Subject: Work Plan - Addendum I

ICES 7016

Subject: Work Plan - Addendum I
Sunny Piedmont Cleaners
Oakland, California

Figure 1

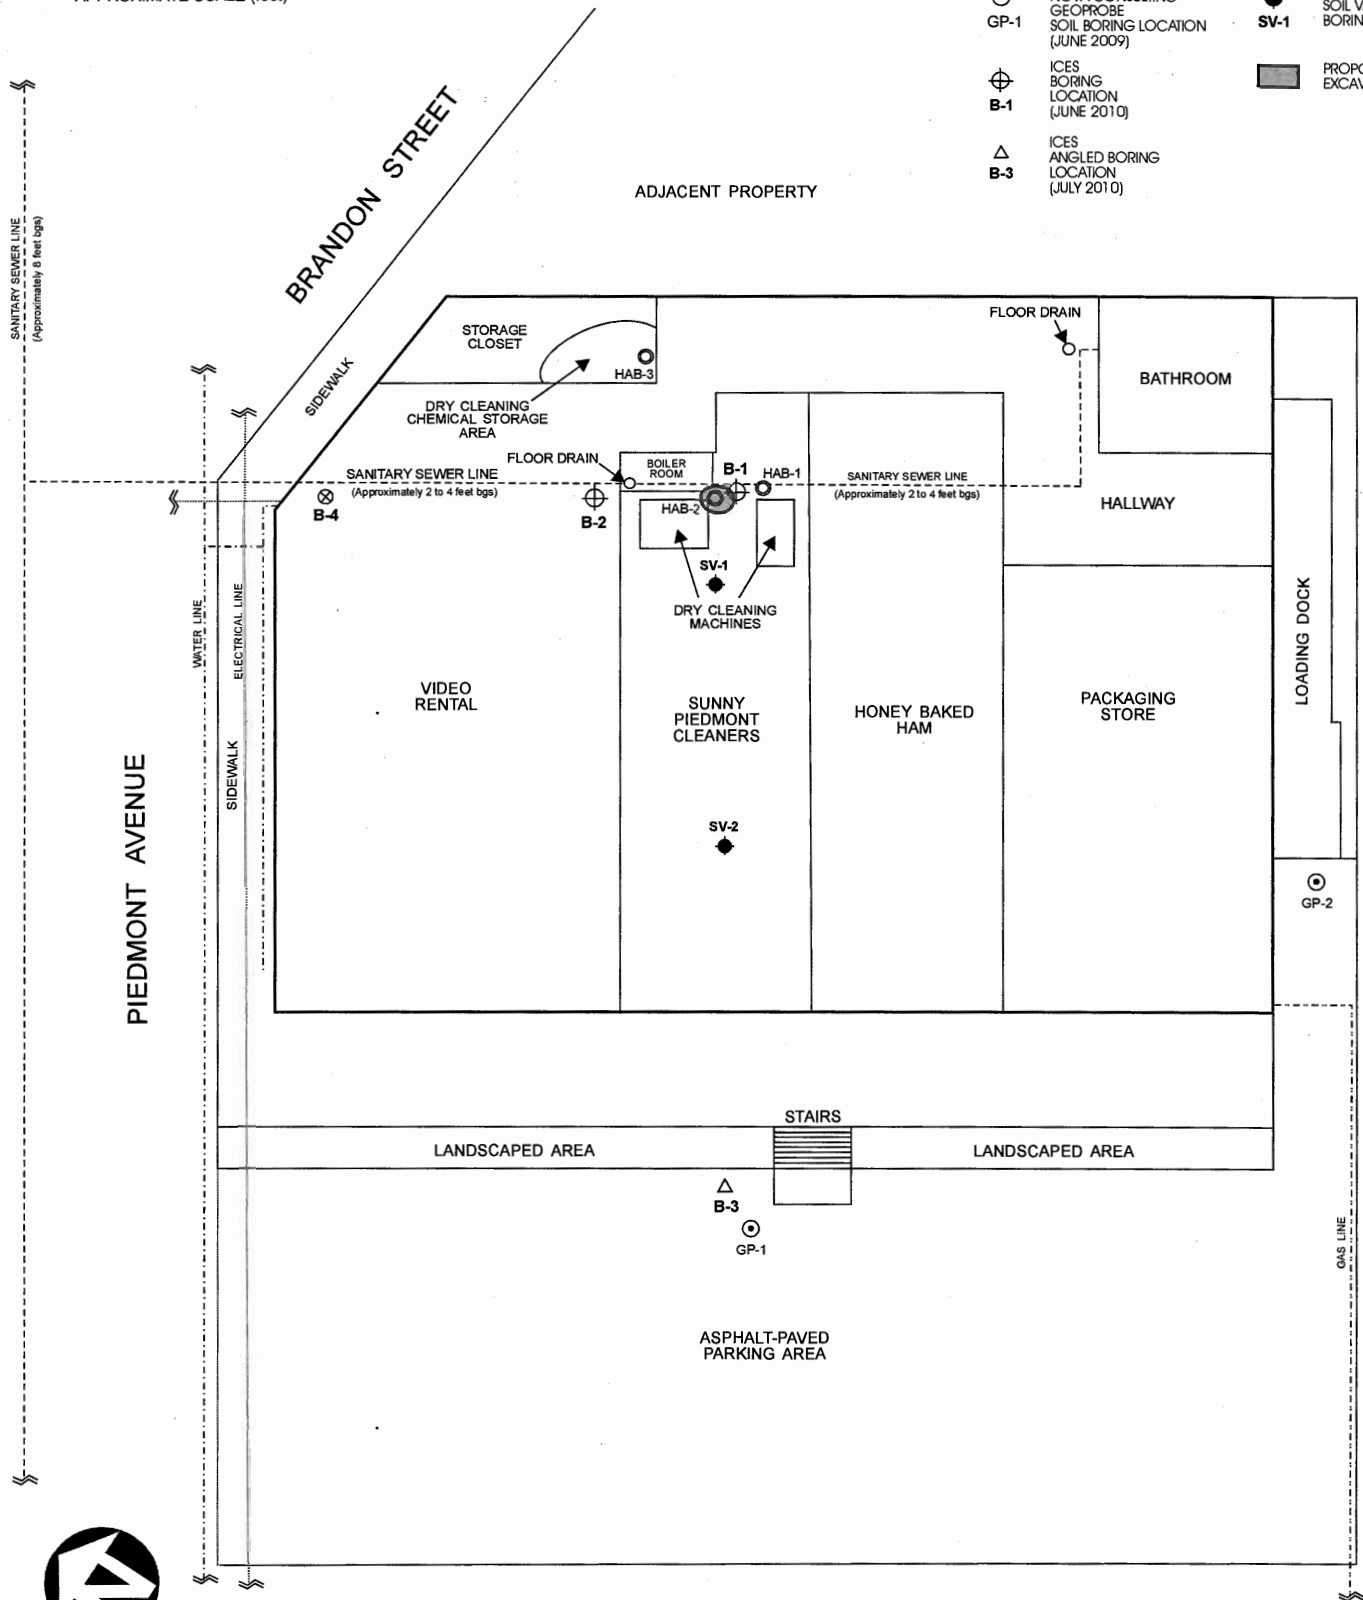
The work plan does not specify soil vapor sampling procedures nor does it reference the guidance that was used. Please submit an addendum to the work plan for soil vapor confirmation sampling that at a minimum provides information on the method used to install the sub-slab vapor probes, depth of probes, details the use of an appropriate tracer gas and a shroud, included appropriate sample quantity, sample frequency and atmospheric gas analysis, and proposes appropriate purging and leak testing.

Two sub-slab soil vapor samples will be collected from two onsite boring locations (SV-1 and SV-2) located at the eastern and western portion of the Site (Figure 1) following the soil removal activities. Two rounds of soil vapor sampling will be conducted: one round will be conducted within a week following the soil removal activities and the second round will be conducted four weeks later.

An electric Roto Hammer equipped with a 1.5-inch bit will be used to drill 1 inch into the cement slab. The cuttings will be removed and a 5/8 inch bit will be used to drill through the remainder of the slab and 3 to 4 inches into the sub base material. The hole will be cleared of any cuttings and debris. The sample train, constructed of 1/8 or 1/4 inch Nylaflo or Telfon tubing with a plastic or stainless steel air diffuser will be attached, and inserted through the slab into the sub base. #30 kiln dried sand will be poured into the hole up to the base of the slab. 1 inch of dry granular bentonite will be poured into the hole, surrounding the tubing. Hydrated bentonite will be placed in the hole and up to the surface of the slab. The sub-slab sampling point will be allowed to equilibrate for a minimum of 30 minutes before sampling.

After equilibration, three volumes of air will be purged from the tubing prior to the collection of the soil vapor samples. Additionally, a tracer compound, difluoroethane or iso-propanol, will be used to test for leaks around the sampling tubing at the ground surface. The tracer will be placed under the shroud during the leak testing. If the tracer is detected per California EPA advisory specifications, another sampling point will be constructed and the process of purging and leak testing will be performed.
